ITEM 4. SECTION 96 MODIFICATION APPLICATION: 1 ALFRED STREET SYDNEY**FILE NO. D/2015/1049/B****DEVELOPMENT APPLICATION NO: D/2015/1049/B****SUMMARY****Date of Submission:** 31 October 2016**Applicant:** Wanda One Sydney Pty Ltd**Architect:** Crone Partners**Developer:** Wanda Group**Owner:** Wanda One Sydney Pty Ltd**Cost of Works:** \$554,000,000

Proposal Summary: This Section 96(2) application seeks consent to modify the approved Stage 1 State Significant Development (SSD) consent for two mixed use towers known as 'Tower A' and 'Tower B' at 1 Alfred Street, Sydney.

Figure 6: View of proposed awning extension (l) and approved building envelope (r) at L39

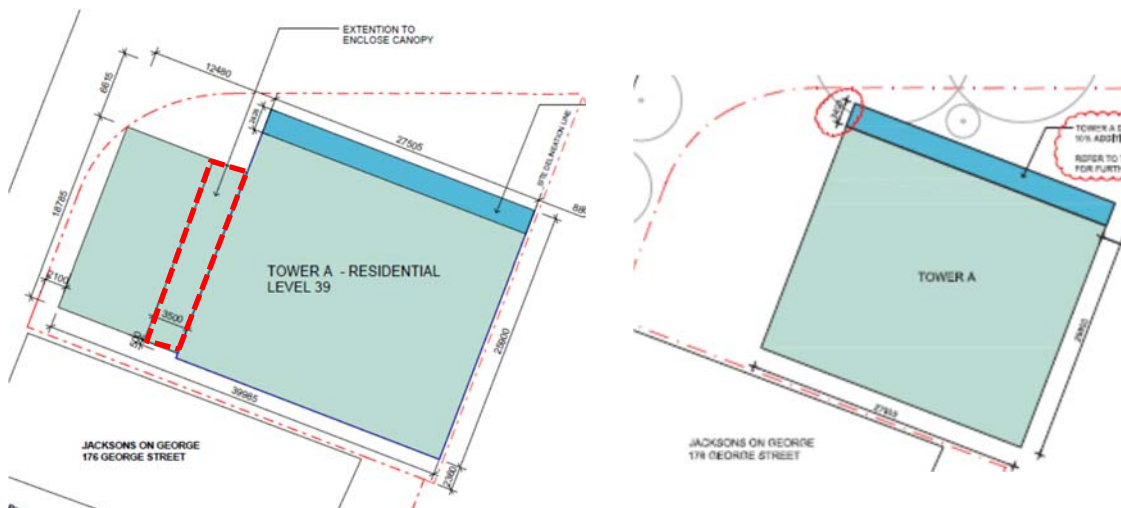
29. The application proposes to modify the building envelope by providing an awning structure at Level 39 (refer to Figure 6). The awning is intended to extend over the terrace entrances, providing protection to residents against falling debris and water as well as improving overlooking between Level 39 and upper level apartments. As per the submitted Wind Report, an awning/canopy structure will also improve local wind conditions on the terrace.
30. The proposed awning will be assessed as part of the concurrent Tower A Stage 2 modification (D/2015/882/C). Notwithstanding this assessment, no objection is raised to an extension of the envelope at Level 39 to accommodate the provision of a terrace awning.

Figure 8: View of approved southern elevation (l) and proposed southern elevation

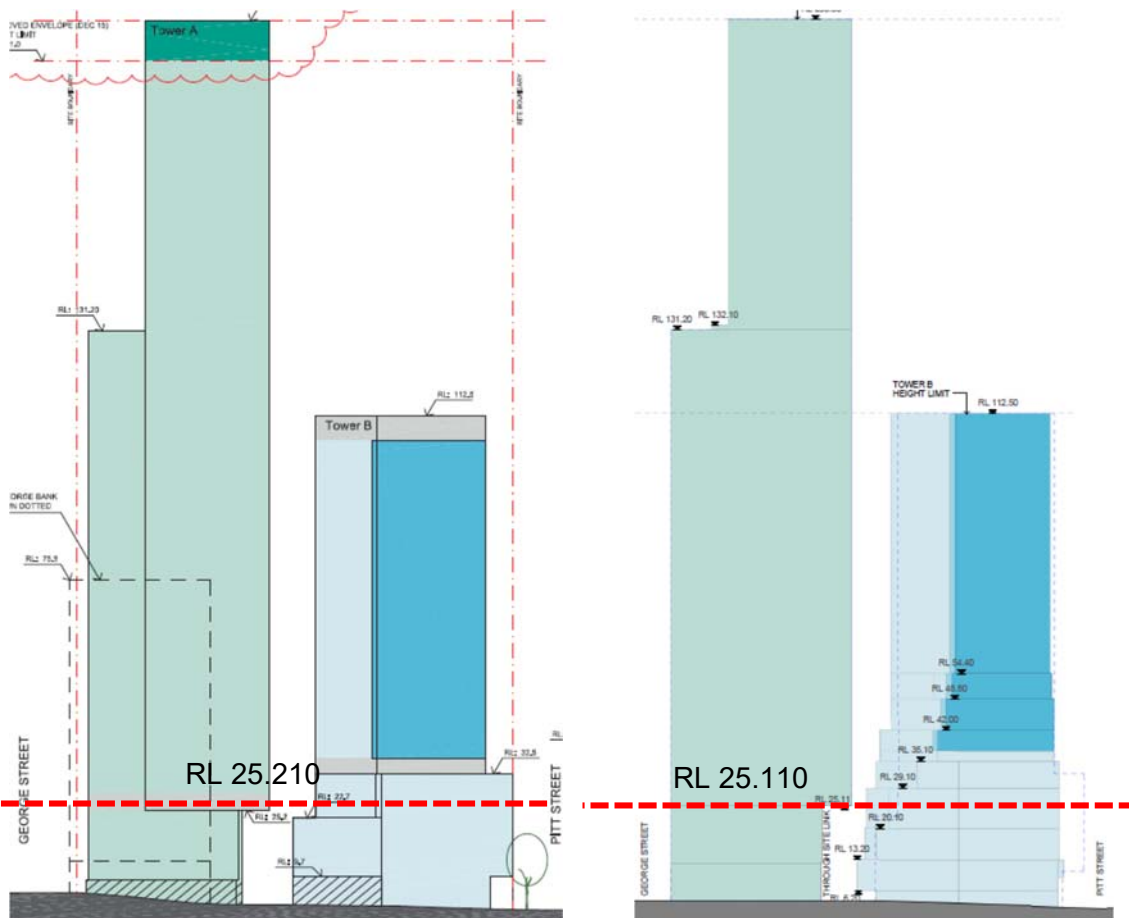
31. The applicant proposes to lower the underside of the cantilever tower element (above Level 6) by 100mm from RL 25.210 to RL 25.110. This modification has emerged through further design development and the necessity to maintain consistent facade detailing. Figure 8 below contrasts the current approved and proposed southern elevation.

32. The proposed 100mm variance in the height of the tower soffit is imperceptible from all aspects of the building. The modification will have no impact upon the bulk or scale of the tower, and will maintain the aperture to the sky when viewed from within the through site link.

Figure 9: View proposed podium to Pitt Street (l) and approved podium to Pitt Street (r)

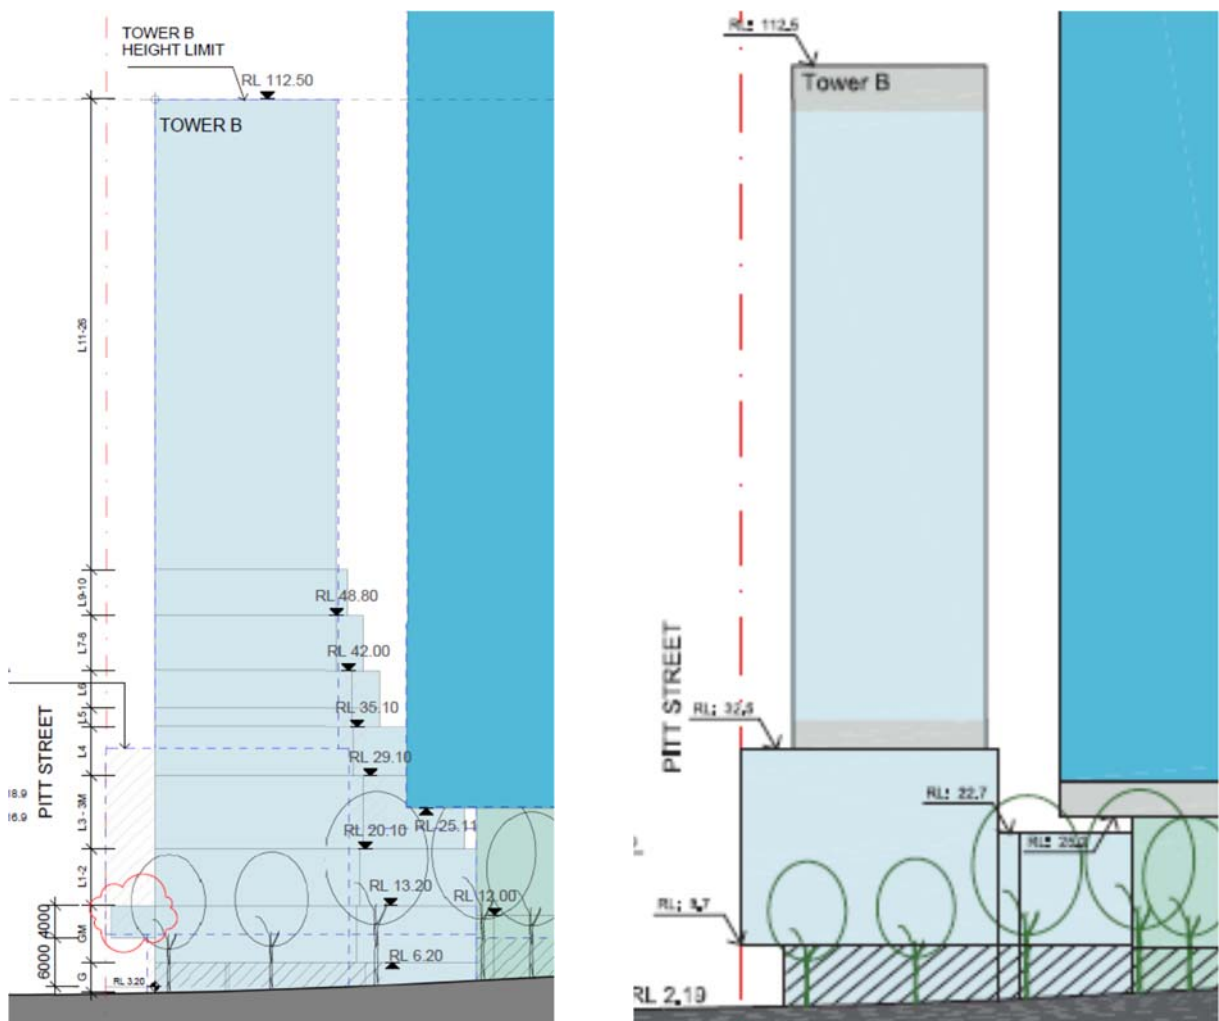
33. The application proposes to reduce the massing of the podium to Pitt Street and realign the lower building form as illustrated in **Figure 9**.

34. The modification responds to the winning Stage 2 detailed design prepared by Kengo Kuma and Associates (KKA) and Crone. The unique 'pixelation' and modulation of building elements was a fundamental aspect of the winning scheme and considered to provide for a more active and intricate ground plane. The modification will enable improvements to the built form and public domain by allowing a stepped geometric expression in the lower levels (Ground – Level 11) of the building envelope.
35. A photomontage of the pixelated Hotel Lobby is provided at **Figure 10** over page. The montage captures a northern view point.

Figure 12: Envelope changes from a NE view (L) and SW view (R) – the green shape indicates the previously approved building form

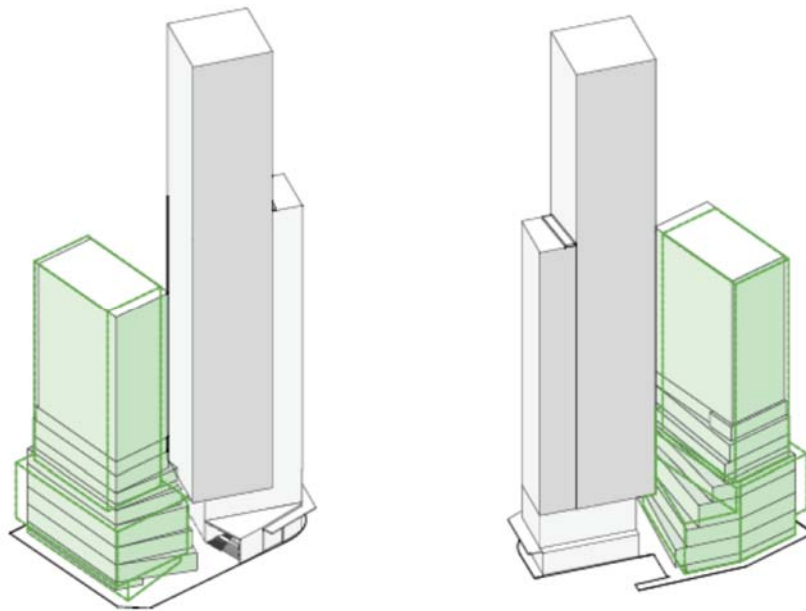
43. The application proposes to shift the upper building envelope a further 5.1m toward the northern boundary (above Level 4). Repositioning the tower will increase the maximum upper level setback from the southern boundary to approximately 9m. This setback will provide greater separation from the future Lendlease Circular Quay (LLCQ) tower located immediately south of the site at 180 George Street, Sydney.

44. In modifying the envelope and pixelating the facade, the building separation of Tower A and Tower B will be reduced at the lower levels between Ground and Level 9. However, the buildings will benefit in some improvements in separation at Level 3.

49. The proposed setbacks do not comply with the minimum separation required by the Apartment Design Guide for residential-to-residential uses and residential-to-commercial uses. Although the amended proposal reduces the separation between Tower A and Tower B from a minimum 10.4m to a minimum 8.8m (above Level 5), the modifications generally maintain or improve the setbacks from development to the south and the east. The minor loss of separation between Tower A and Tower B does not result in any additional amenity impacts such as overlooking, as the western elevation to Tower B is primarily solid with some secondary window insertions adjacent the lift lobby corridor. Hotel rooms are also located at the most northern and southern corners of the floor plate, with views oriented away from the residential apartments in Tower A.

Figure 13: An overlay of Ground and upper tower setbacks on Tower A and B in relation to adjacent development and site boundaries

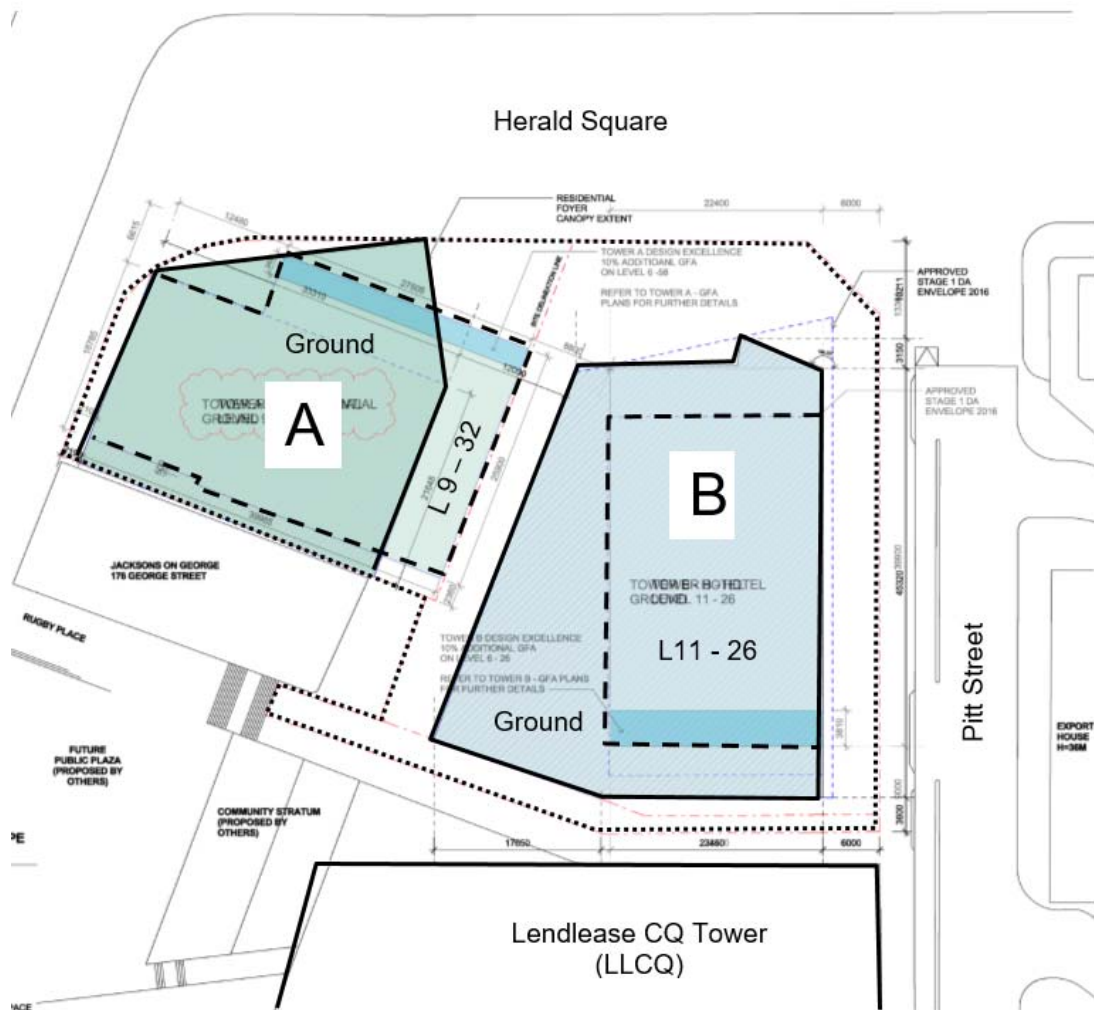
46. The proposal includes the following setbacks:
 - (a) 6m ground level setback to Pitt Street;
 - (b) 6m upper level setback to Pitt Street;
 - (c) an average 10m ground level setback to Herald Square;

- (d) approximately 13m upper level setback to Herald Square;
 - (e) 3.6m ground level setback to southern boundary; and
 - (f) 9m upper tower setback to southern boundary.

47. Building separation between Tower A and B has been revised to between:
 - (a) 5.3m and 17.1m at the podium/lower levels;
 - (b) 8.8m and 19.2m at the tower;

- (c) 6.8m ground level separation between Tower B and LLCQ; and
 - (d) 12.2m tower separation between Tower B and LLCQ.
48. **Figure 12** and **13** provide an illustration of these setbacks and building separations.

Figure 15: View from LLCQ at RL 120 (north-west)

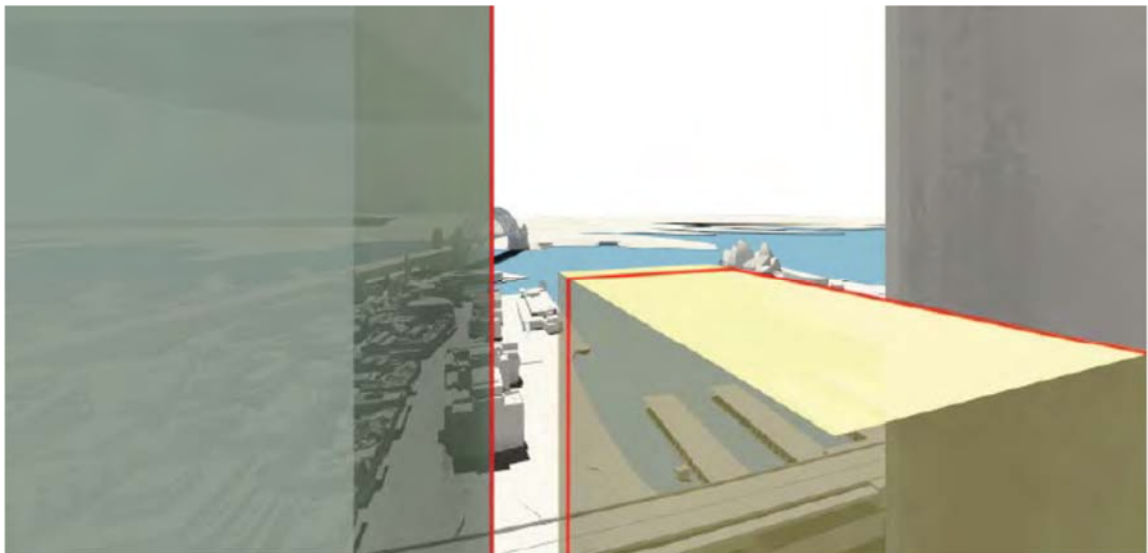
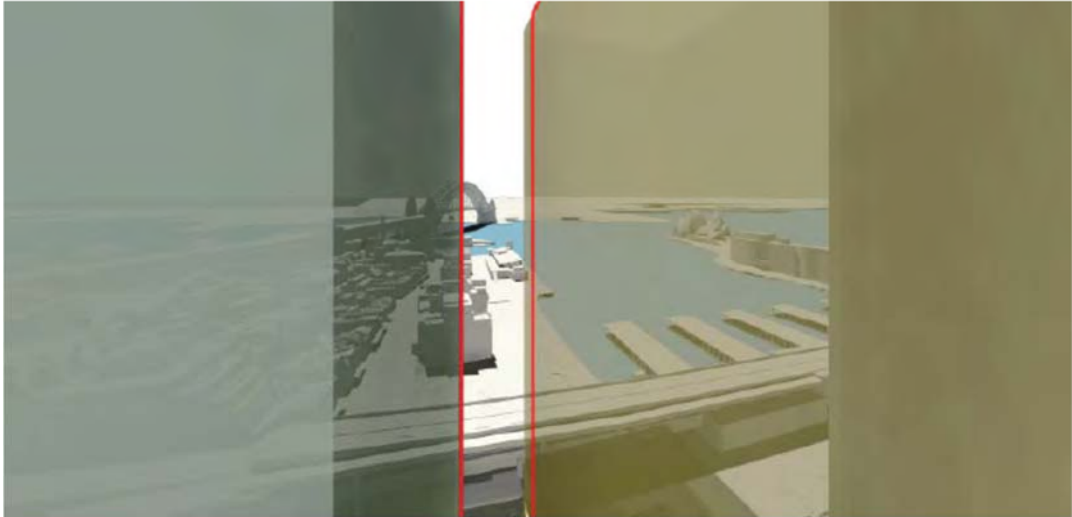
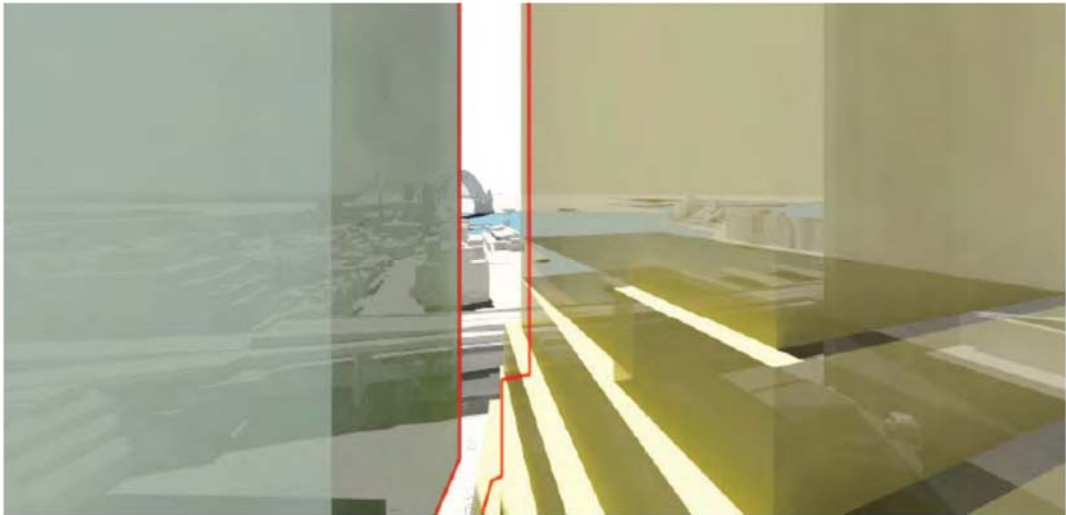
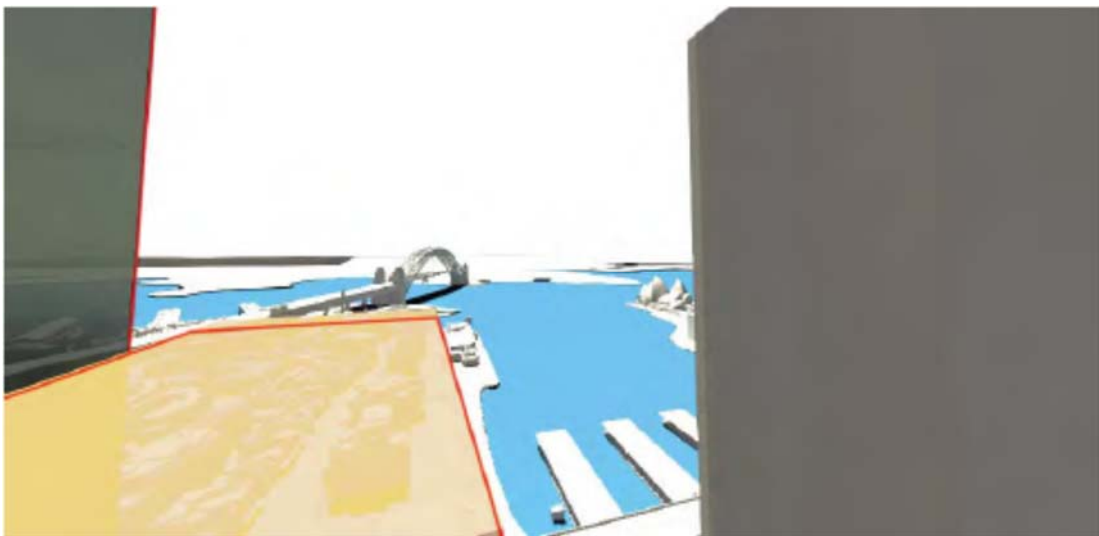
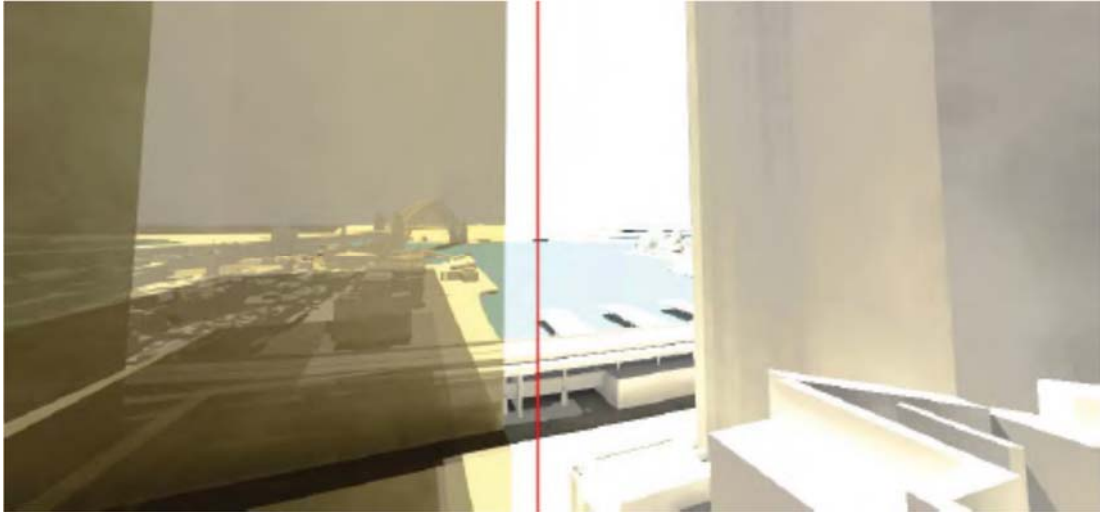
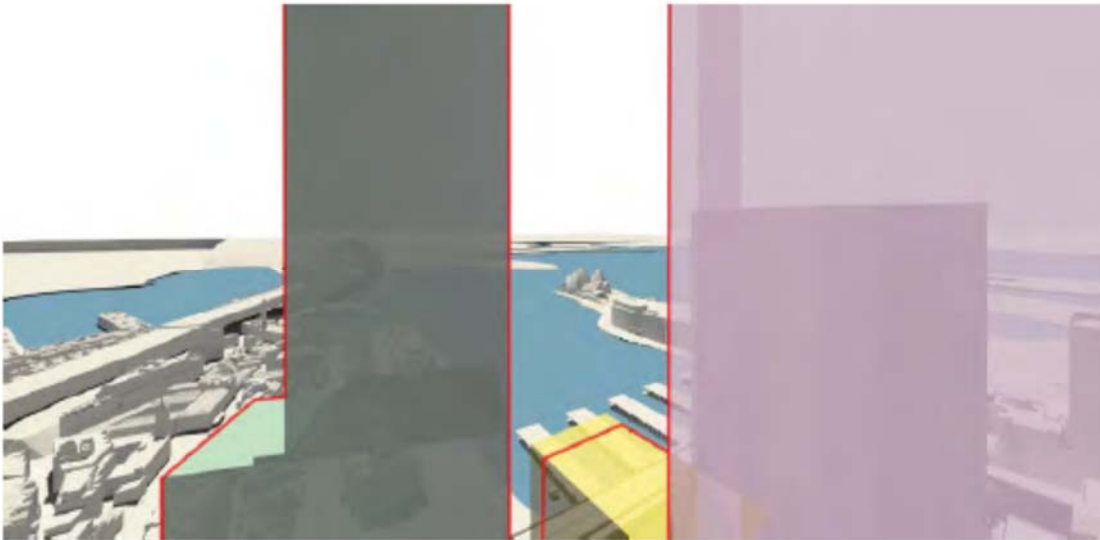
- (a) The modified building envelope will cause minor impacts to the view corridors of commercial development south of the site. Namely, '200 George Street' and the future LLCQ tower. It is noted that in some instances, views are slightly improved by the realigned envelope, including those from the Marriot Hotel. Views from Grosvenor Tower and the Cove Apartments remain unaffected by the modification.
- (b) **Figure 15 – 23** below illustrate the view impacts from '200 George Street' and the LLCQ, providing a comparative analysis of the current approved envelope and subject proposal:

- (c) The extent of view loss from LLCQ and 200 George Street is imperceptible. The revised building envelope does not eliminate any iconic views or significant vistas and in some locations, improves upon views for sites south and west of the development. In this regard, no issue is raised to the modified tower envelope.
